BRENT ACRES SUBDIVISION, RESUBDIVISION OF LOTS 3 AND 4

APPLICATION NUMBER 9 DATE May 5, 2016
APPLICANT Brent Acres Subdivision, Resubdivision of Lots 3 and 4
REQUEST Subdivision

DETAIL SITE PLAN

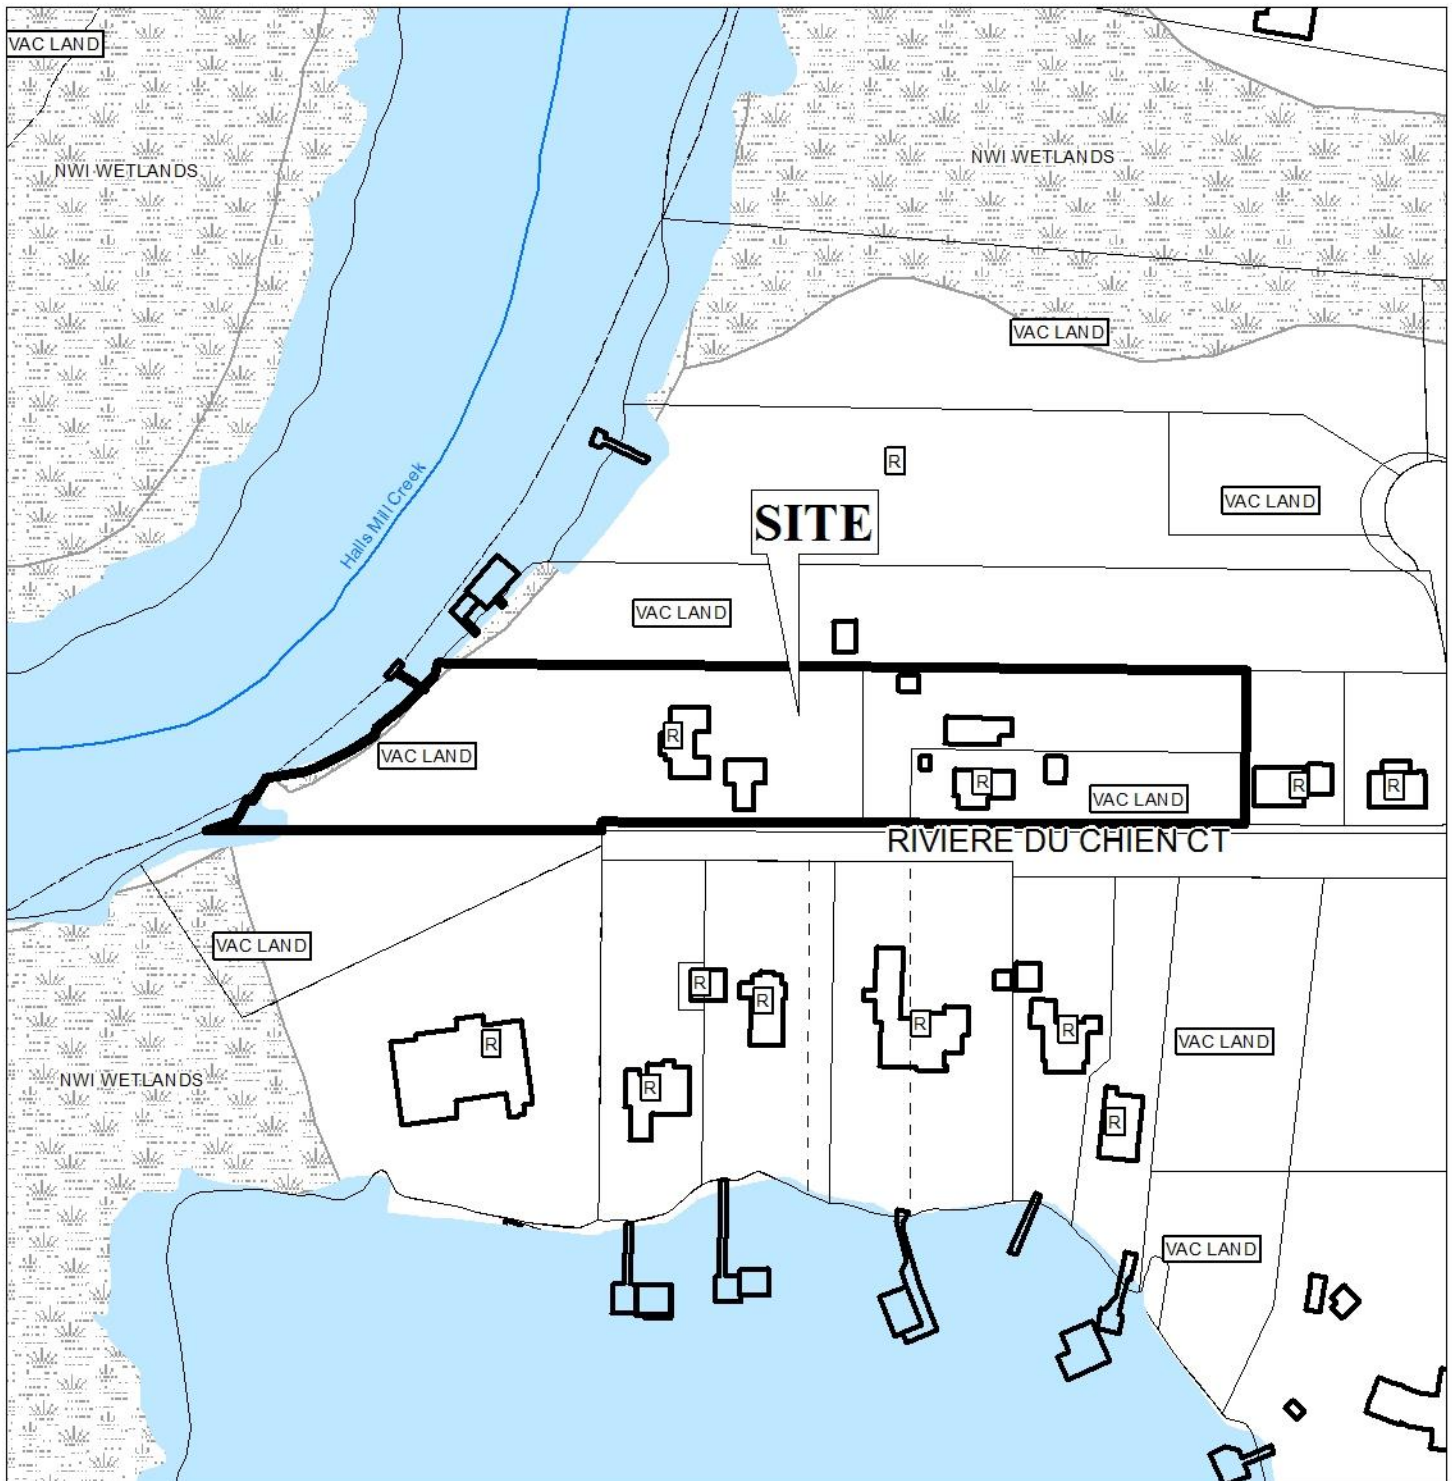
The site fronts onto Riviere du Chien Court, a minor street with a substandard 40' right-of-way. Dedication was recorded via the original Subdivision to provide 25' from the centerline of Riviere du Chien Court; therefore, no further dedication would be required. The plat indicates

the 25' minimum building setback line along Riviere du Chien Court and this should be retained on the Final Plat.

As a means of access management, the Final Plat should retain the note stating that the driveway number, size, location and design are to be approved by Traffic Engineering and conform to AASHTO standards.

Each lot meets the minimum area and width requirements of the Subdivision Regulations. As on the preliminary plat, the Final Plat should also label each lot with its size in both square feet and acres, or a table should be furnished on the Final Plat providing the same information.

- 1) retention of the 25' minimum building setback line along Riviere du Chien Court;
- 2) retention of the note on the Final Plat stating that the driveway number, size, location and design are to be approved by Traffic Engineering and conform to AASHTO standards;

- 3) retention of the labeling of each lot with its size in square feet and acres, or the furnishing of a table on the Final Plat providing the same information;
